Product Change Notification

Change Notification #: 109807 - 00
Change Title: DH55TC/DH55HC, PCN 109807-00, Product Material, Added a warning label to the processor socket lid
Date of Publication: January 25, 2010

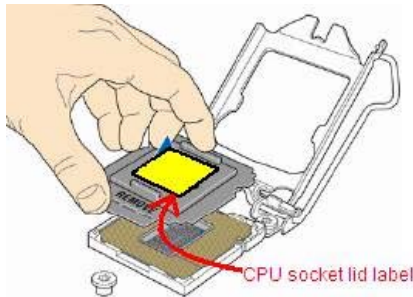
Added a warning label to the processor socket lid as shown below.
